**APPROACH FOR ADDING  
PERFORMANCE-BASED STRESS RUPTURE VERIFICATION  
TO GTR#13 IN PHASE 2**

G.W.Scheffler  
October 2018

- At the June meeting of the hydrogen vehicle GTR #13, a performance-based approach to evaluate stress rupture of Type 3 and 4 composite over-wrap pressure vessels (COPVs) was presented based on the recent revision to SAE J2579.
- The purpose of this presentation is to follow up on comments and questions raised during the review at the June meeting.

# EXAMPLE OF FEA PREDICTIONS FOR TYPE 3 COPV

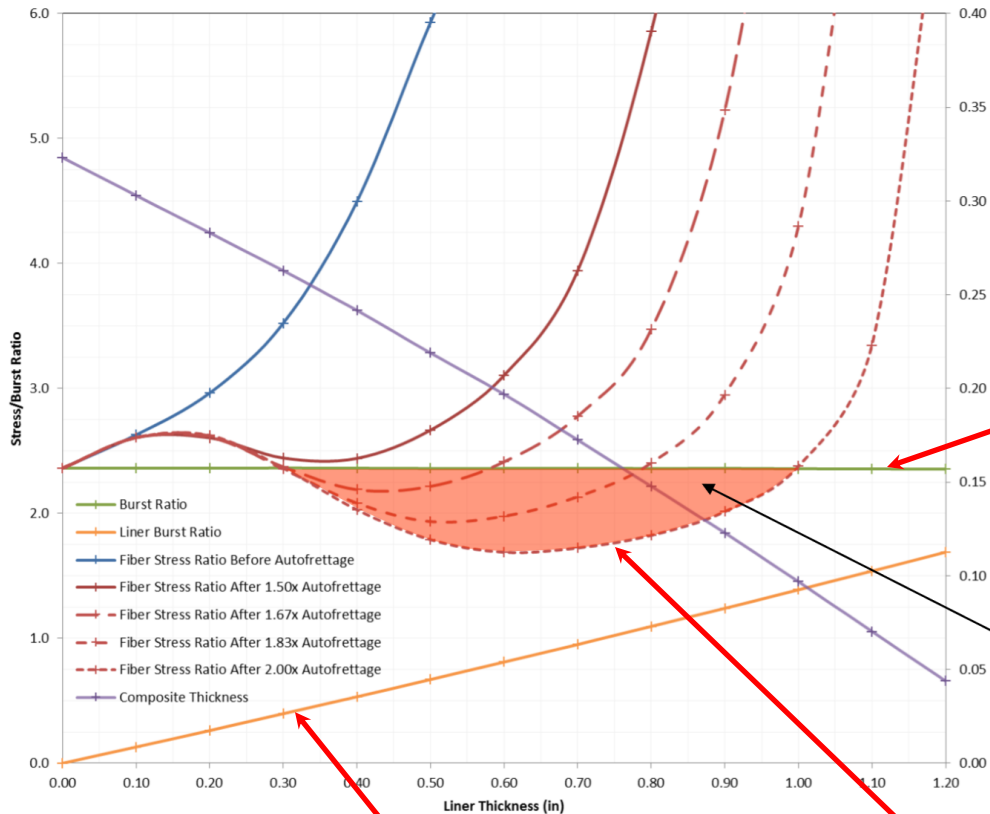
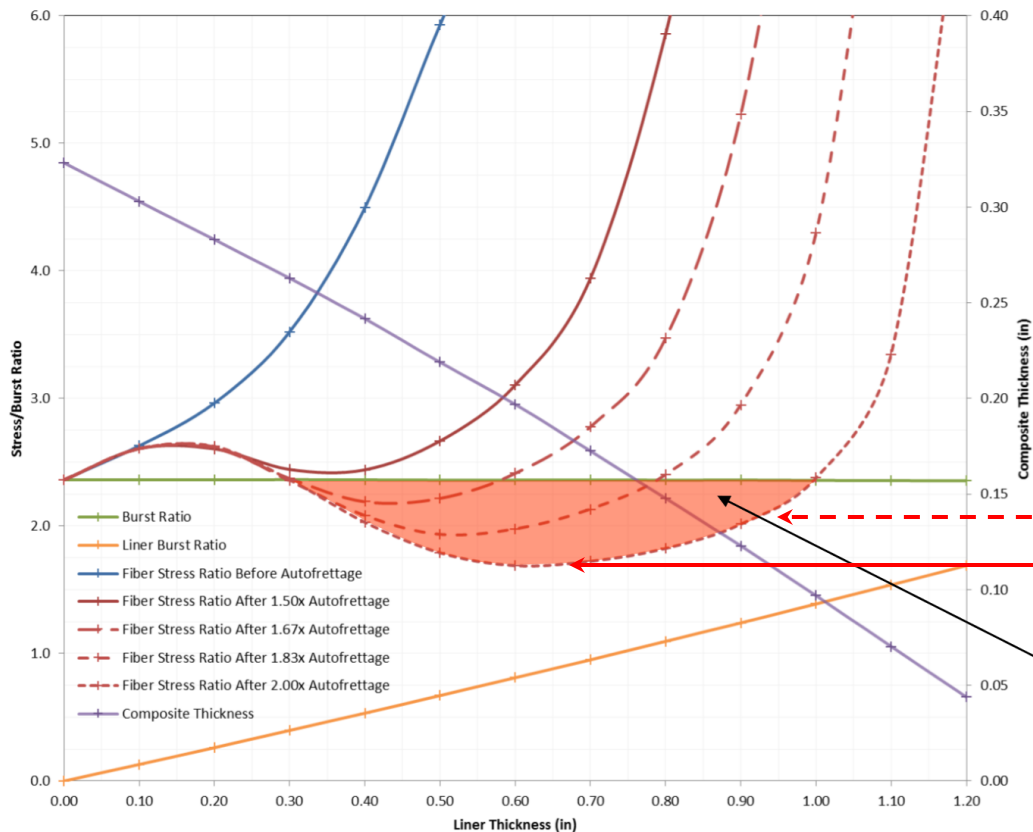
- 1) Does (or can) the liner of a Type 3 COPV place a load on the composite over-wrap? If so, how much additional stress?
- 2) Can the performance-based test used with Type 3 COPVs?

- “Thick” metal liners of a Type 3 vessels can place additional pressure ( $P_{ml}$ ) on the composite over-wrap at elevated autofrettage pressure.
- To retain the possible added stress of an autofrettaged liner,  $P_g$  should not exceed  $1.5 \times \text{NWP}$  during stress rupture testing.

**Type 3 liner increased**

**Shaded region is where stresses in composite are higher than indicated by burst ratio.**

***CONCLUSION: Analysis at 85C IS required to judge effectiveness of the proposed stress rupture withstand test in detecting problems.***
